Re: John Marshall Kitchen Facility, 2540 Karsten Ct. SE,

Request for Permanent C.O. -Accepted

Re: John Marshall Kitchen Replacement Facility, 2540 Karsten Ct SE, Approved Plan Stamp Date 1-11-11 (M14/D004C) Certification Date 2-9-12 – Not Approved

Re: John Marshall Kitchen Replacement Facility, 2540 Karsten Ct SE, Grading and Drainage Plan

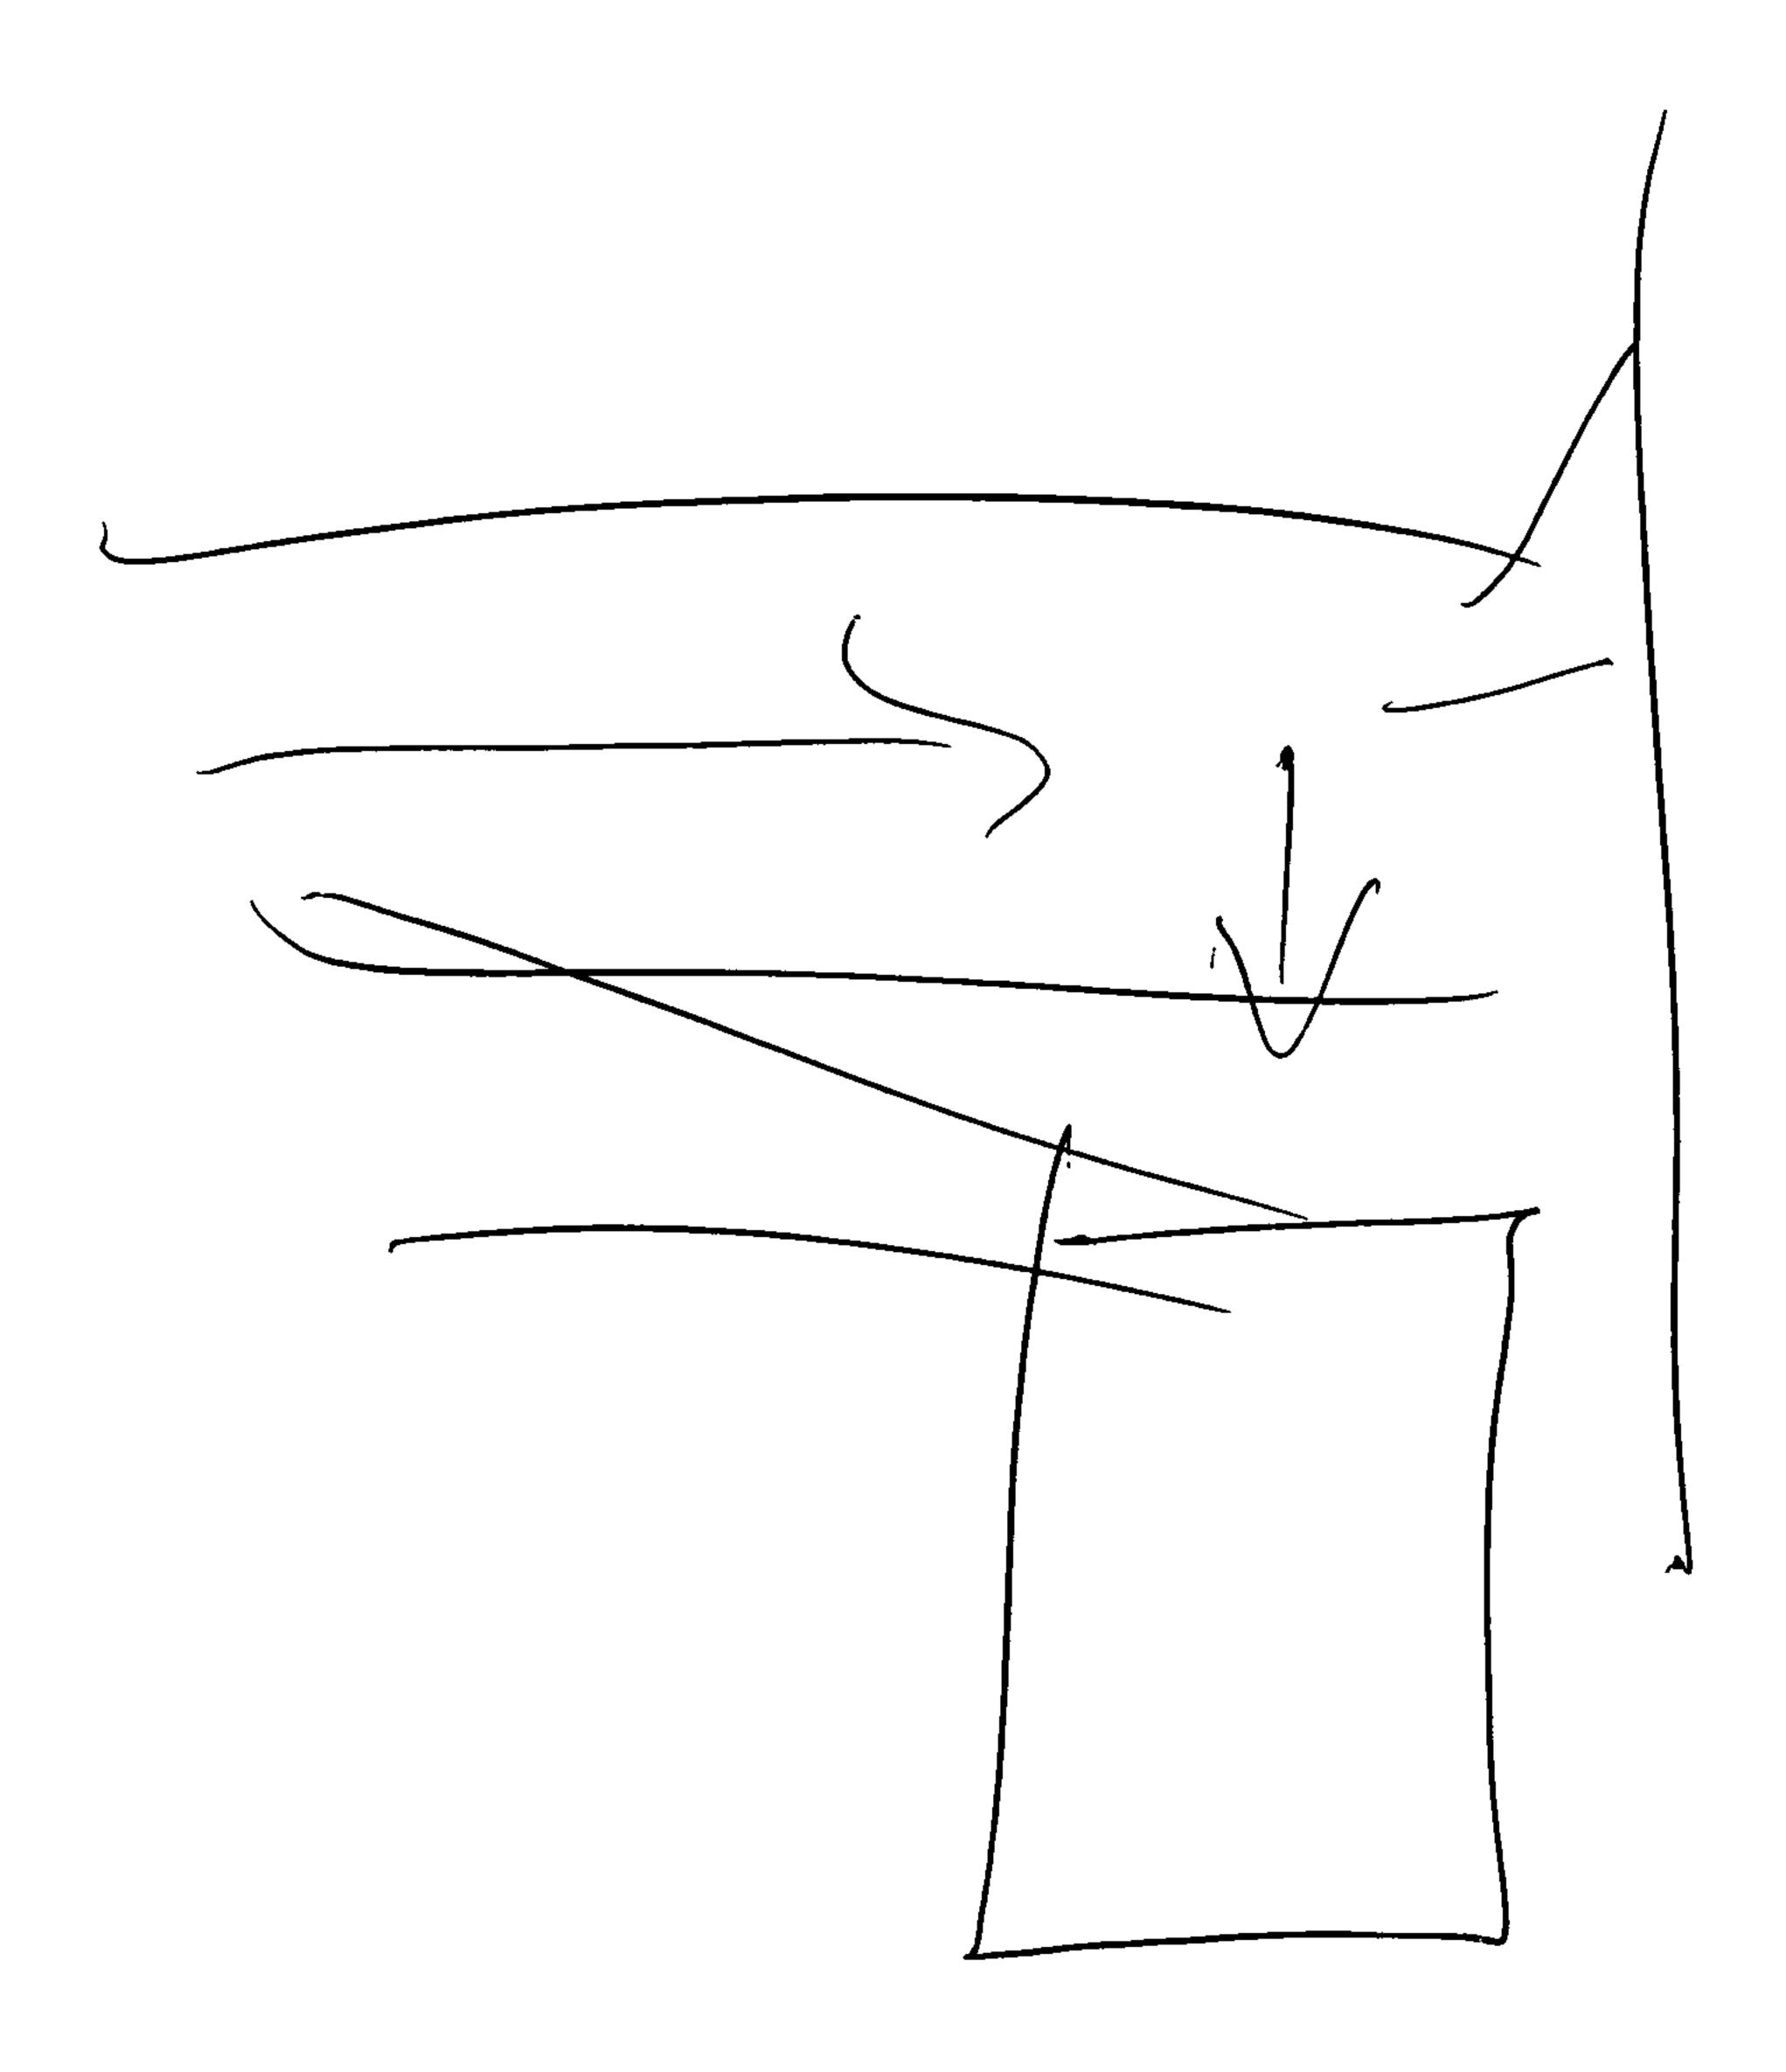
• Per a site visit on 2-14-12 and photos, drainage in the south half of the site does not enter the inlet near the south entrance.

• Per the approved Grading Plan a water harvesting area in the northwest area of the site was to aid in preventing sediment from entering the street as well as for LID purposes. It seems that rather than digging the water harvesting area a berm was dumped. A change from a depressed area to a berm is acceptable; however, the berm needs some compaction. One should not sink 8 inches into the berm when walking on it.
